## #2015-66 Casey's Gas Station – Special Use Permit Project Review for Planning and Zoning Commission

**Meeting Date:** February 3, 2016

**Location:** 639 E. Terra Cotta Avenue (Route 176)

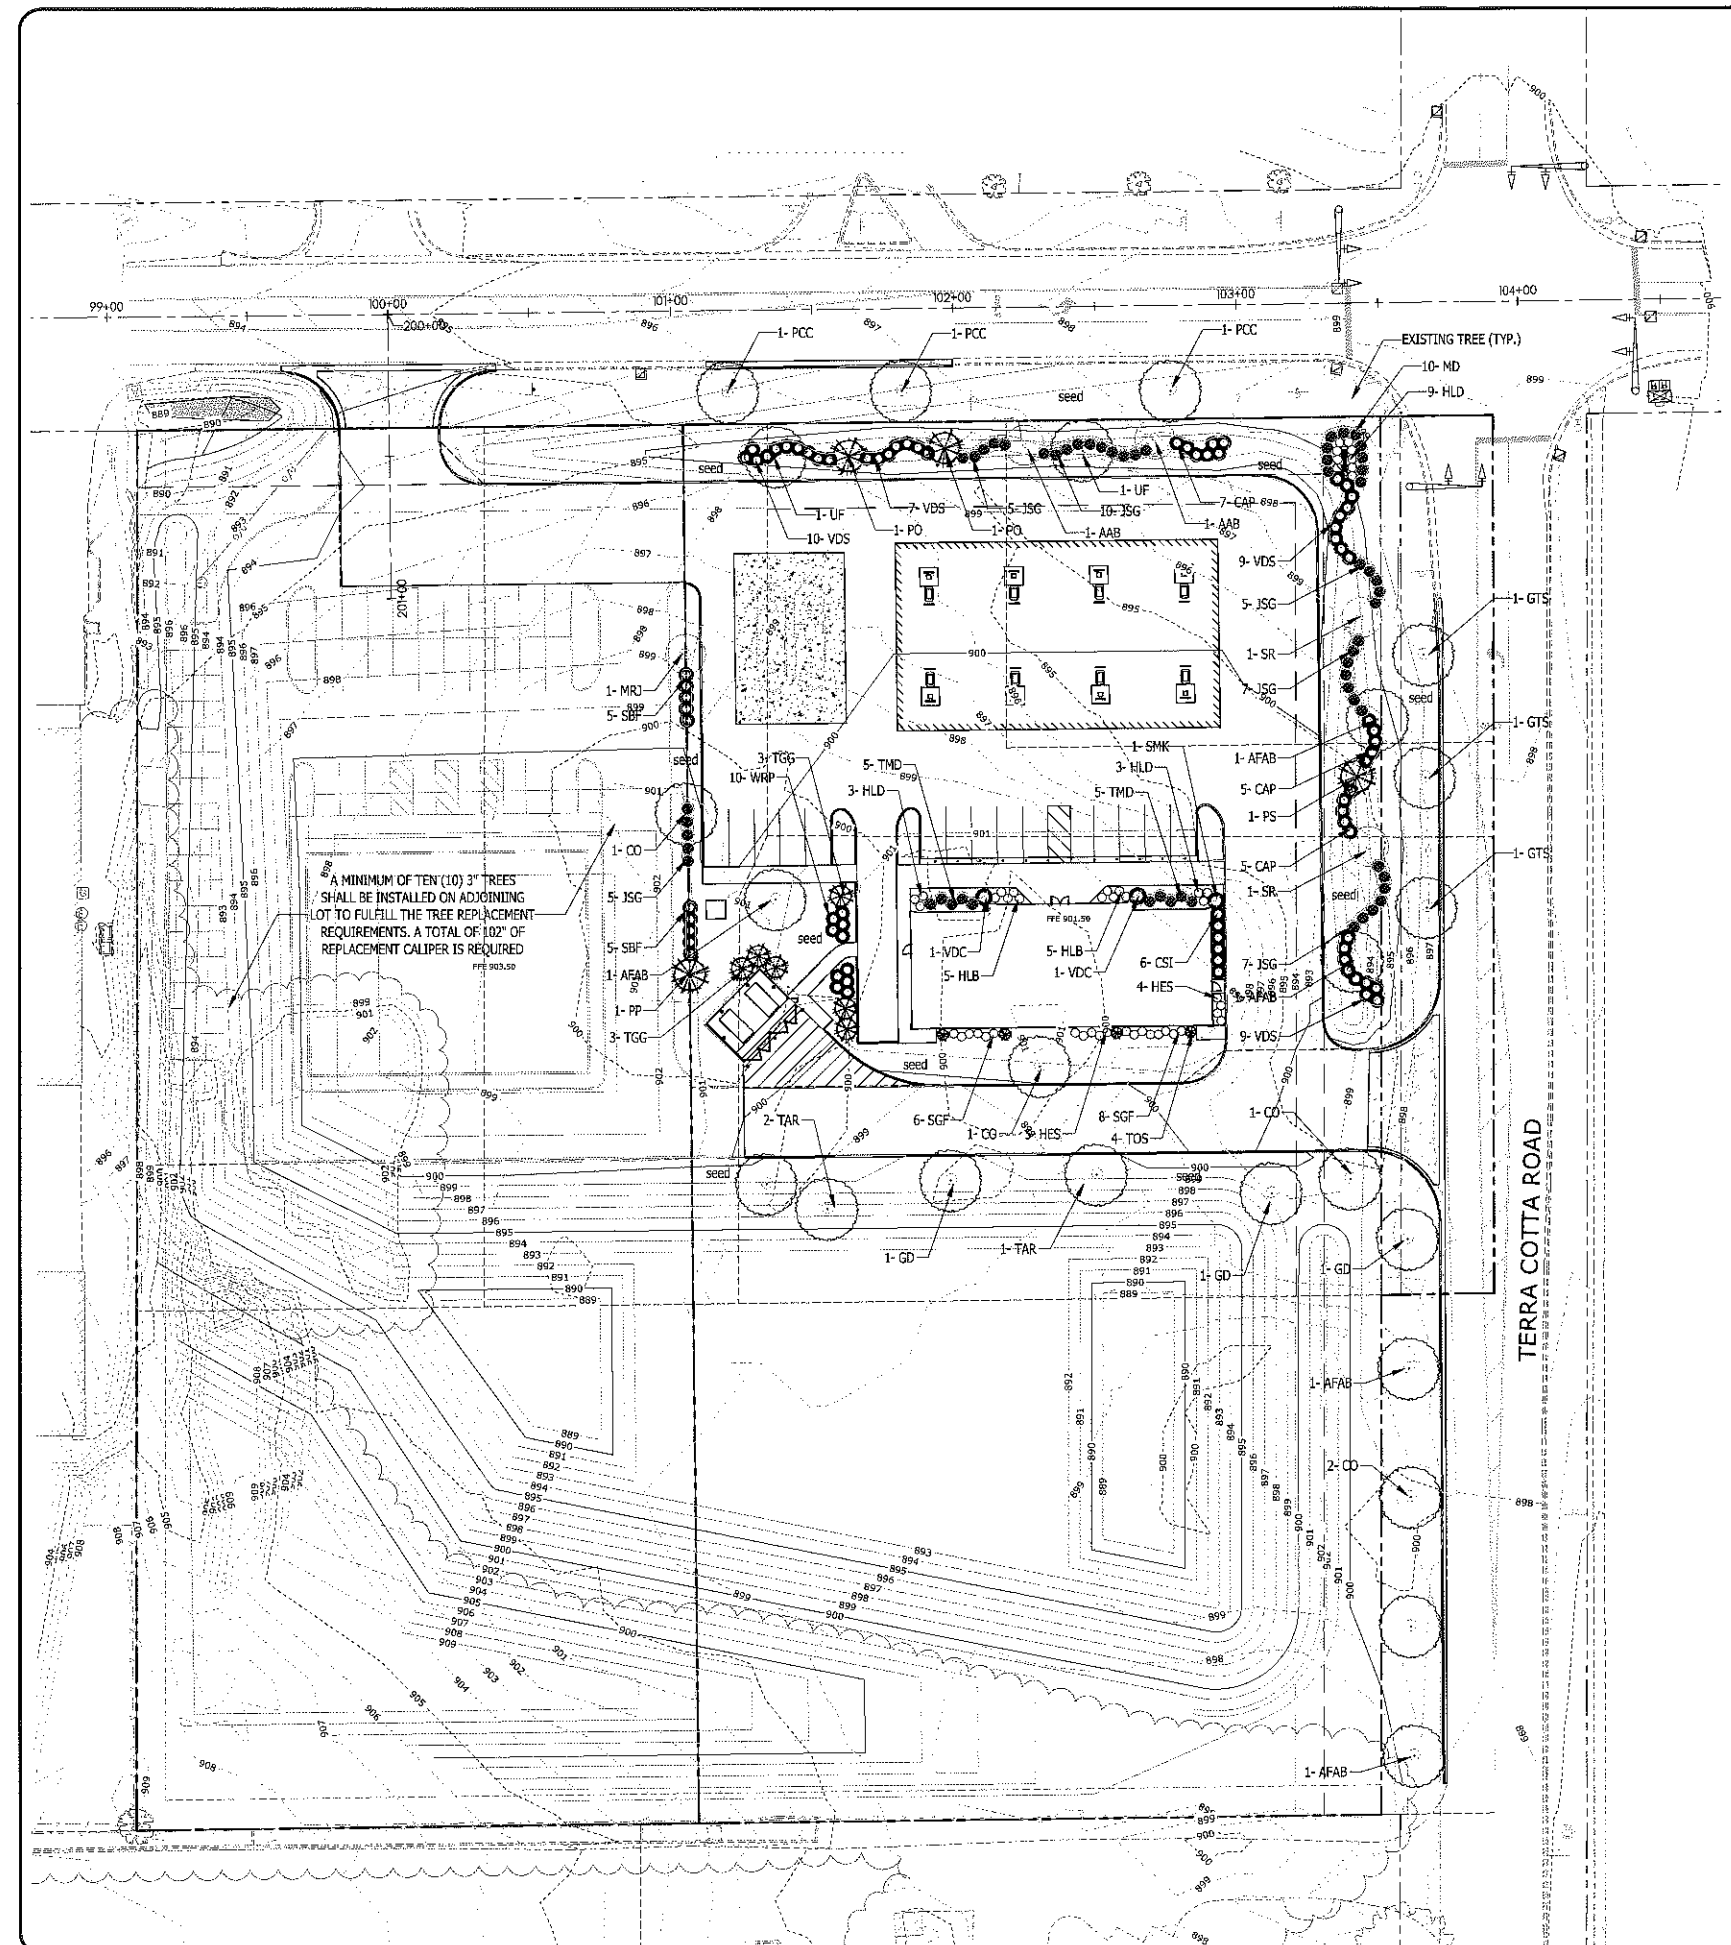
- Foundation base landscape has been added around the building on three sides. The only side that does not have the foundation base landscape is the west side where the loading area is.
- Trees and shrubs need to be added to the landscape islands in the parking lot. A condition of approval has been added regarding this.

- H. Environmental Impact Statement (St. John-Mittelhauser, dated 01/25/16, received 01/26/16)
2. Site and Landscape Plan
  - A. Add trees and shrubs to the landscape islands to meet the UDO requirements.

COUNTY HIGHWAY CERTIFICATE

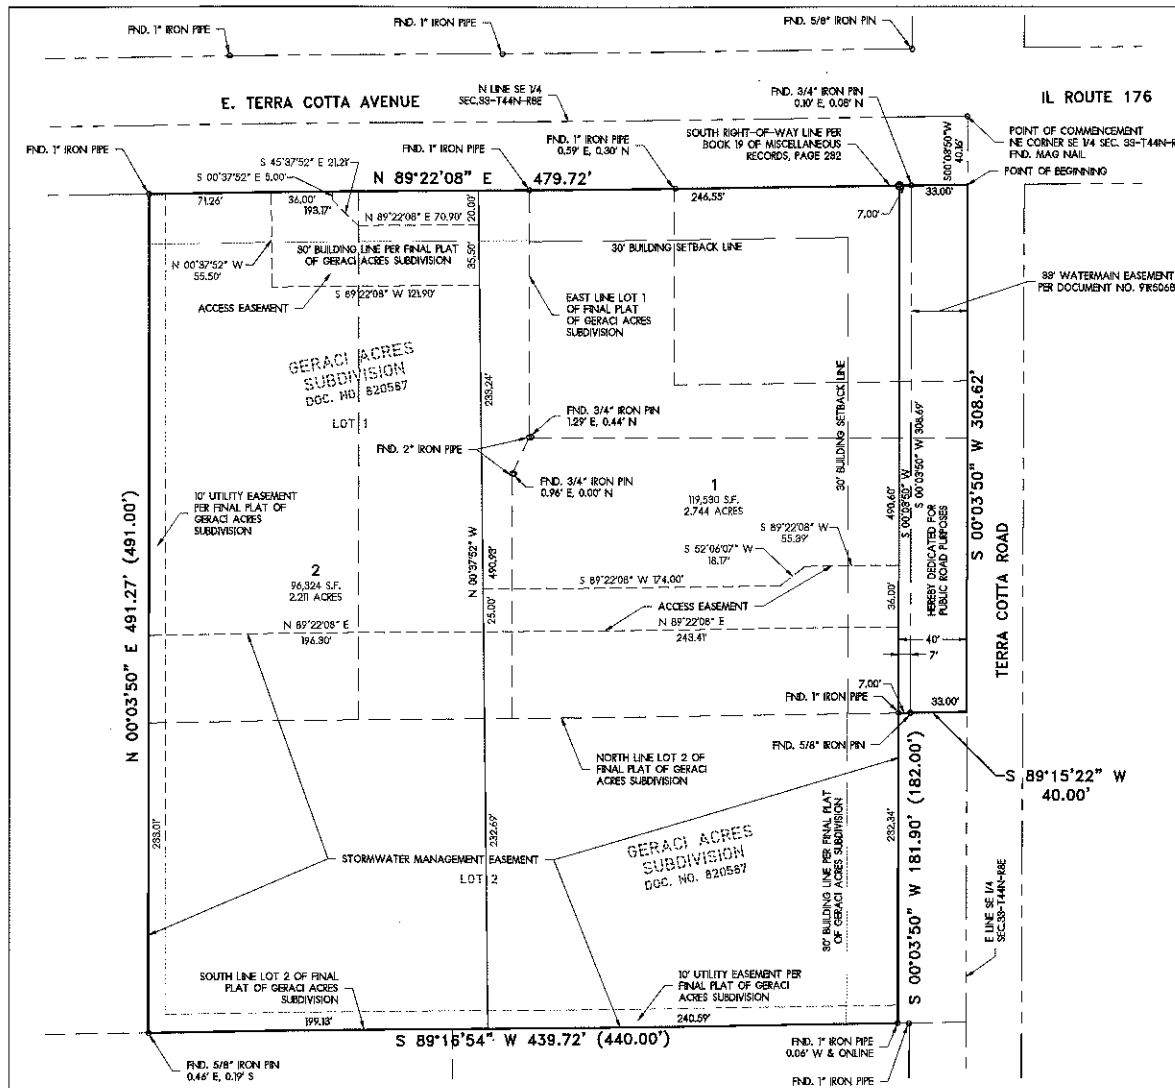
- A. The "County Highway" signature block needs to be amended to an IDOT signature block.
4. Provide the City with a hazard mitigation plan illustrating proper procedure in case of a spill or emergency.
